Bulletin No.: L03-007
Release Date: 8/31/06
Effective Date: Immediately
Supersedes: N/A
Completion Date:
Sept. 15, 2006
Page: 1 of 2

SERVICE BULLETIN

Ride Manufacturer: Larson International Inc. Affected Production Dates: All
Ride Name: HI-ROLLER PORTABLE MODELS AND
CRAZY TRAIN PORTABLE MODELS

Mandatory Bolt, Nut, and Washer replacement schedule for track sections

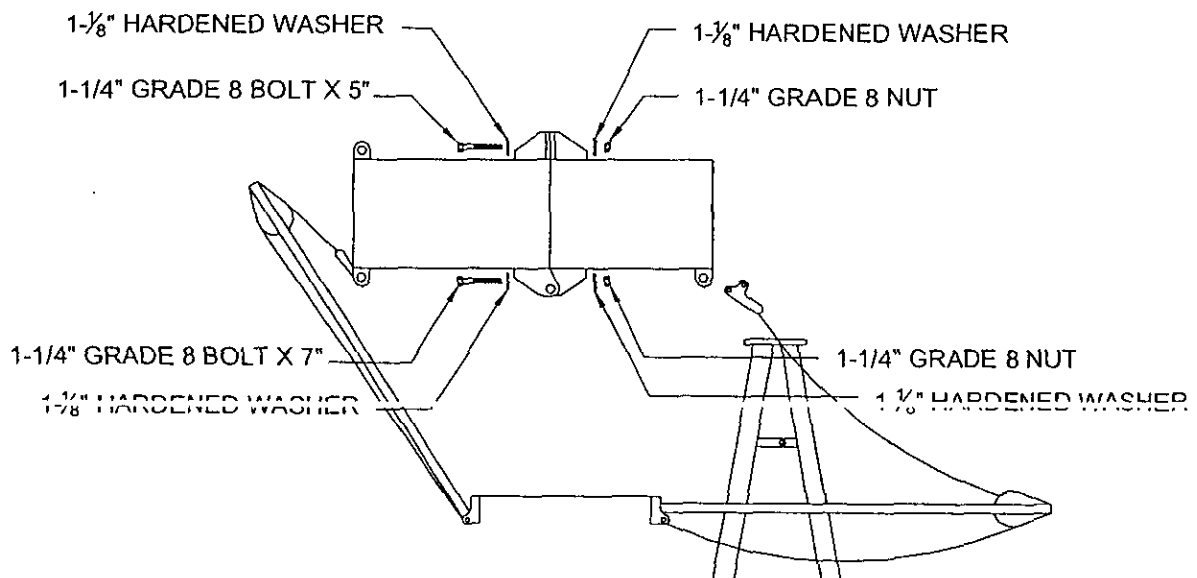
Larson International Inc. has learned that the Grade 8 bolts, Grade 8 nuts, and hardened washers being used to fasten the two track sections together on the Crazy Train and Hi-Roller rides are being replaced with substandard bolts, nuts, and washers. There is reasonable concern that serious personal injury and property damage could result from failure of these fasteners.

1. Remove all ten, 1-1/4" bolts, nuts, and washers currently being used to fasten the two track sections together.
2. Replace with 1-1/4" Grade 8 UNC bolts, Grade 8 UNC nuts, and 1-1/8" hardened washers purchased from Larson International, Inc.

3. All bolts and nuts must be dry torqued to 400 foot pounds with a torque wrench.
4. Proper bolt tension must be checked daily with a torque wrench to 400 foot pounds of torque.

5. All bolts, nuts, and washers must undergo a visual inspection each time the ride is erected checking for corrosion, thread damage, bending and cracking. If any corrosion, thread damage, bending or cracking is seen or if excessive torquing is required to remove the bolts and nuts they must be replaced immediately.

6. All hardware must be purchased from Larson International, Inc. to ensure proper quality, size and grade.
7. All hardware must be initially replaced no later than September 15, 2006. If replacement is not completed by this date the ride must be taken out of service until replacement is complete.

8. The entire set of bolts, nuts, and washers must be replaced annually after initial replacement.
